Re: Section 16 Planning Application for Proposed Temporary Open Storage of Construction Materials and Construction Equipment for a Period of 3 Years at Lot Nos. 1809 (Part), 1813, 1814, 1815 (Part), 1816, 1817 (Part), 1819, 1820, 1824, 1825, 1826, 1827, 1828, 1829, 1830, 1831 S.A, 1831 S.B, 1832, 1833, 1834, 1835, 1837, 1838, 1839 (Part), 1840, 1841, 1842 and 1843 in D.D. 129, Lau Fau Shan, Yuen Long, New Territories
(Planning Application No. A/YL-LFS/522)

We refer to the latest comments from Transport Department (dated 16.10.2024) and would like to enclose herewith our Responses-to-Comments Table and Revised Traffic Impact Assessment to address the abovementioned departmental comments for their consideration.

Drawing Title -	2024 Observed Link Flow (Veh/hr) During AM & PM Peak Hours

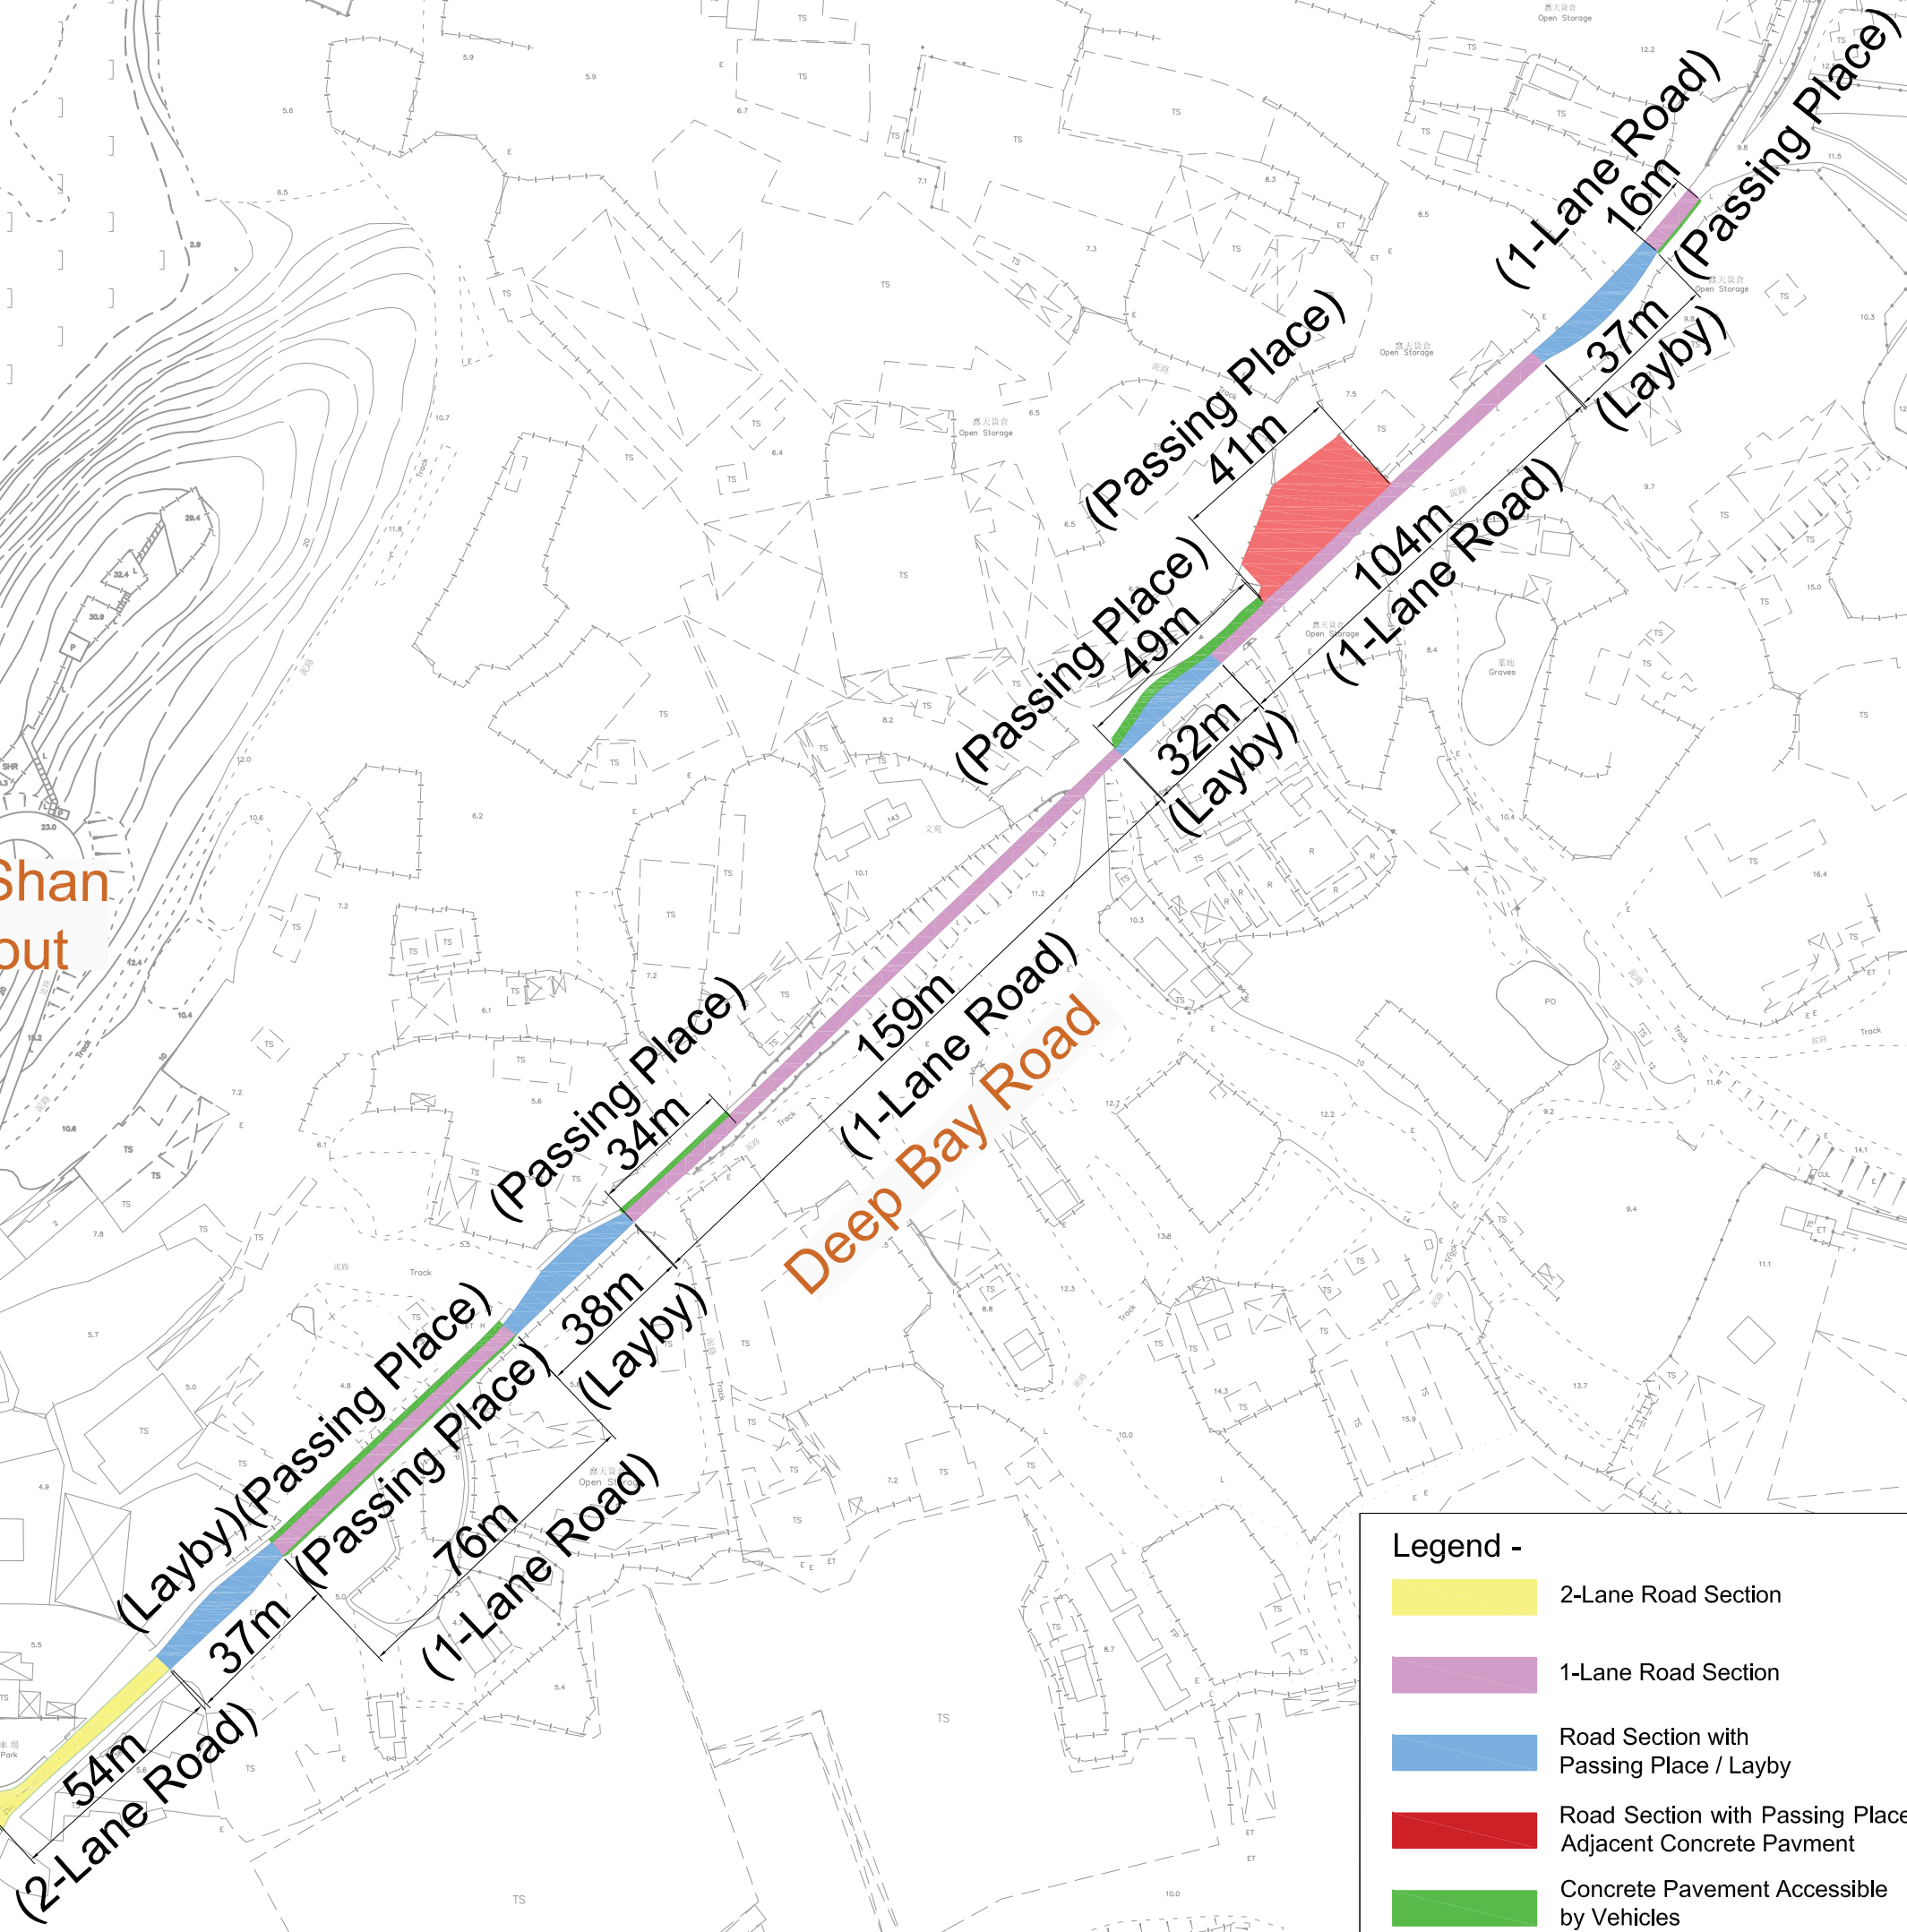
No.	Comments	Responses
Comments from Transport Department		
1	Our previous comment that 1 ha of open storage area for storing 25-30 tons of goods is over-provided in term of site area has not been addressed yet. Please clarify. You could provide photos / photomontage to aid your presentation.	According to the applicant, approximately 25 to 30 tons (5-6 LGVs) of goods would be transported to the application site daily, rather than storing 25 to 30 tons of goods in total, the estimated tons of goods align with the trip generation & attraction generation every day. A drawing with photo demonstration (drawing no.: 80108-01-01) is attached for your reference.
2	According to TPDM V2 Ch. 3.11.3.1, a single track road when provided with adequate passing places can accommodate 2-way flows of 100 vehicles per hour, which is different from the design capacity in this table. It is noted in Figures 5.1 and 5.2 that the traffic flow at Deep Bay Road exceed 200 pcu/hr, which exceed the capacity of the road. Please consider to provide physical road improvement works to mitigate the traffic impact arising from the proposed development, particularly near Lau Fau Shan Roundabout.	Please see section 3.4.1 in the updated TIA report for the determination of link capacities, the traffic flows at the concerned road links are provided in Figure 3.6, which the flow unit is unified as veh/hr for easy reference.
